8.1.2 DA MCU Valdora App A Assessment Report

Material Change of
Use (Renewable
Energy Facility),
909 Yandina-
Coolum Road,
Valdora

MCU14/0161

Prepared for Sunshine Coast
Council

SUNSHINE COAST COUNCIL
VALDORA SOLAR FARM
STAGE 1A AND 1B
LANDSCAPE CONCEPT PLAN

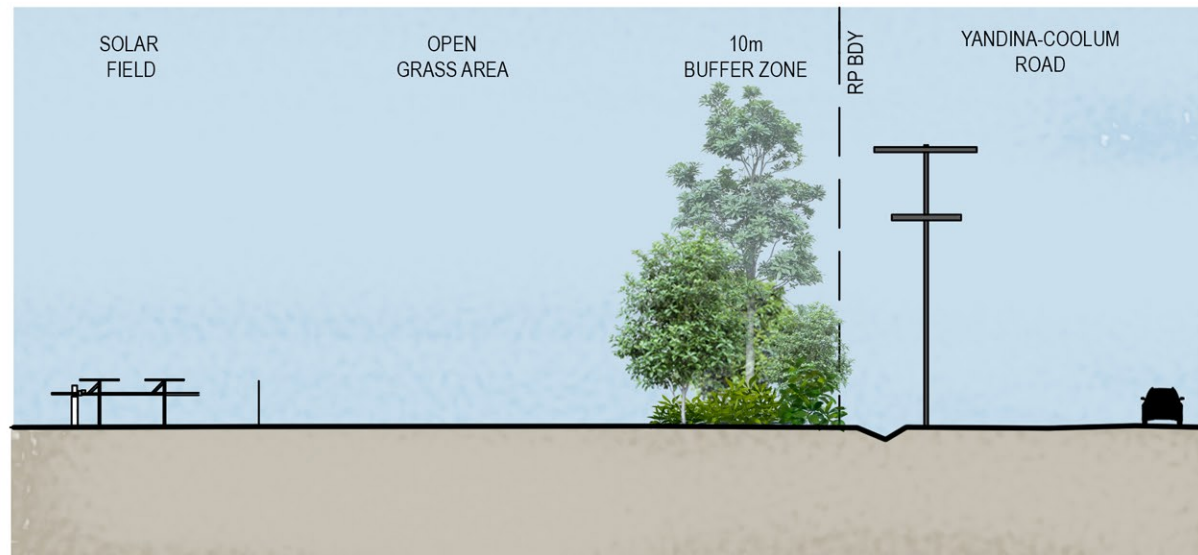
Performance Outcomes		Acceptable Outcomes	GHD Comments	CARDNO COMMENTS	CARDNO INFORMATION REQUEST	CARDNO CONDITIONS
Landscape Code						
			<p>(f) where adjoining the edge of native <i>vegetation</i> or <i>waterway</i> understorey, shrubs and vines are used to bind appropriately the <i>buffer</i> edges against degradation and weed infestation.</p> <p>Note—Figure 9.4.2E (Landscape buffer design) illustrates the preferred configuration of <i>landscape buffers</i>.</p> <p>Figure 9.4.2E Landscape buffer design</p>			
Landscape Screening						
PO21	Development provides for <i>landscape buffers</i> that:- (d) effectively protect the edges of existing native <i>vegetation</i> or	AO21	Where a <i>landscape buffer</i> is required by an applicable use code, local plan code or overlay code, it is designed,	Complies AO21. Landscaping works will comprise a 10m vegetated buffer along the frontage of the site and down the entire length of the southern	It is unclear what the “Low Feature shrub planting area” proposed in Stages 1a and 1b of the	Information was provided on the cross section showing structure of the Low Feature shrub planting area with the other

Performance Outcomes		Acceptable Outcomes	GHD Comments	CARDNO COMMENTS	CARDNO INFORMATION REQUEST	CARDNO CONDITIONS
Landscape Code						
			 <p>Buffer plan view</p>			
Landscape Screening						
PO22	Development provides for complete or partial landscape screening of built form elements, carpark, fences, utilities and storage areas at maturity.	<p>AO22.1 Built form is softened and integrated with the broader landscape by structured landscape planting.</p> <p>AO22.2</p> <p>AO22.3 Landscape screening occupies at least 30% of a building elevation as viewed from the street.</p> <p>AO22.4 Except where otherwise provided by the applicable use code, car parks and driveways are screened by:- (a) a planting bed of at least 1.5 metres wide where adjacent to a residential use; or (b) a planting bed of at least 3 metres wide where adjacent to a</p>	<p>Complies AO22.1 – AO22.2. Landscaping works will comprise a 10m vegetated buffer along the frontage of the site and down the entire length of the southern boundary. Lower level planting is proposed along part of the frontage to screen, soften and integrate structures onsite with the broader landscape. .</p> <p>Complies AO22.3. – AO22.4. The combination of vegetation buffering and lower level planting is to provide a complete screen to the solar panel array from Yandina-Coolum Road. The lower level planting provides a screen to the ancillary equipment and maintenance support precinct to soften its appearance from Yandina-Coolum Road. It is</p>	It is unclear what the “Low Feature shrub planting area” proposed in Stages 1a and 1b of the Landscape Concept Plan will contain.	Information was provided on the cross section showing structure of plants proposed.	A condition requiring the similar treatment of the Low Feature shrub planting area with the other landscape vegetation buffers is required.
